# UNITED STATES PATENT AND TRADEMARK OFFICE

APPLICATION NO.	FILING DATE	FIRST NAMED INVENTOR	ATTORNEY DOCKET NO.	CONFIRMATION NO.
10/526,422	07/05/2006	Roel Daamen	BE02 0022 US	3847

## Office Action Summary

**FIG. 11**

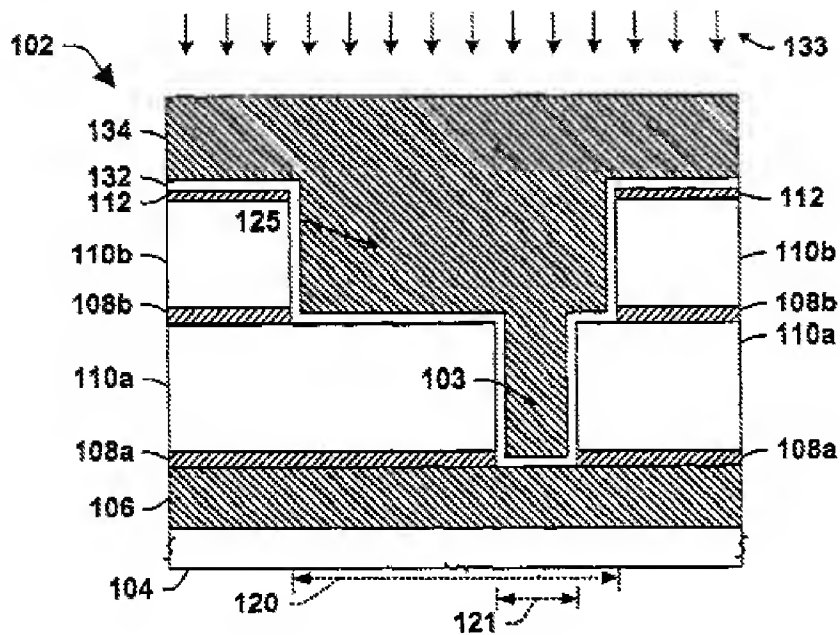
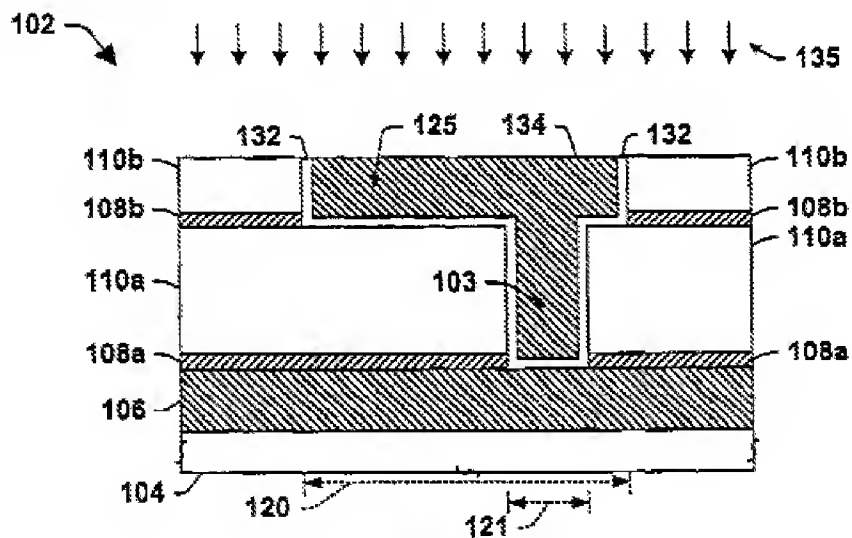
Smith discloses a semiconductor process as claimed. See FIGS. 1-15B, where Smith teaches the following limitations.

Pertaining to claim 1, Smith teaches a method for fabrication of in-laid metal structures, comprising the steps of:

- providing a substrate **4** with a dielectric material **108a** on top thereof;
- depositing a protection layer **110** on top of the dielectric material,

- depositing a sacrificial layer **112** on top of the protection layer, the sacrificial layer having a mechanical strength with is low than the mechanical strength of the protection layer (please note that the figures are not drawn to scale, the silicon carbide layer is relatively thinner than the claimed protection material layer),

- making an opening through the sacrificial layer, through the protection layer and into the dielectric material,
- depositing a barrier layer **132** in the opening and on the sacrificial layer

- depositing a metal material on the barrier layer, the metal material filling the opening,
- removing portions of the metal material existing beyond the opening by means of polishing, and

- removing the barrier layer and the sacrificial layer in one polishing step.

Pertaining to claim 5, Smith teaches a method according to claim 1, wherein the adhesion between the sacrificial layer and the protection layer is weaker than the adhesion between the protection layer and the dielectric material (the Examiner takes the position that because the sacrificial layer **112**, metal layer **134** and barrier layer **132** are removed in one step without removing protection layer **110** by the CMP method, this limitation is taught by Smith).
